Access Compliance Report Public Rights-of-Way (Curb Ramps)

Main Street: MAYBECK_LN		Cross Street: MAYBECK_LN		Location:	E
ADA ID: RPRK211025114144	Ramp Type: Type 1 - Perpendicular	Initial Pass/Fail: Fail	Overall Compliance: No	Severity Score:	2
Codes/Mitigation Info/Possible Solution			Field Measurements/Component Compliance

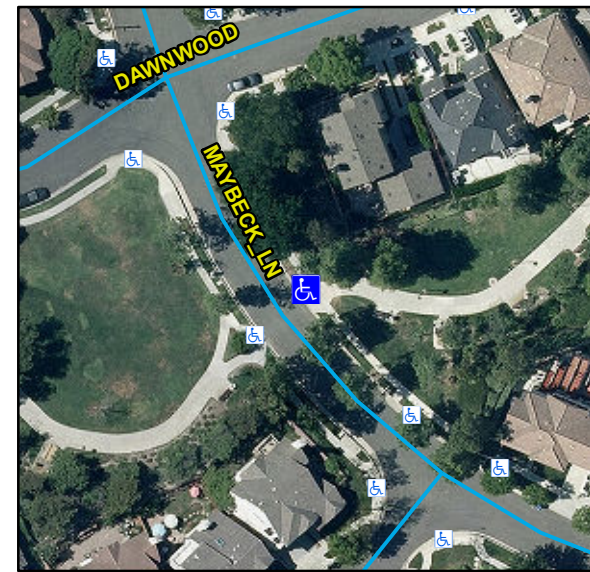
R304.2.2, R204.3, R304.5.3, STD 1115

Remove & Replace Entire Ramp.
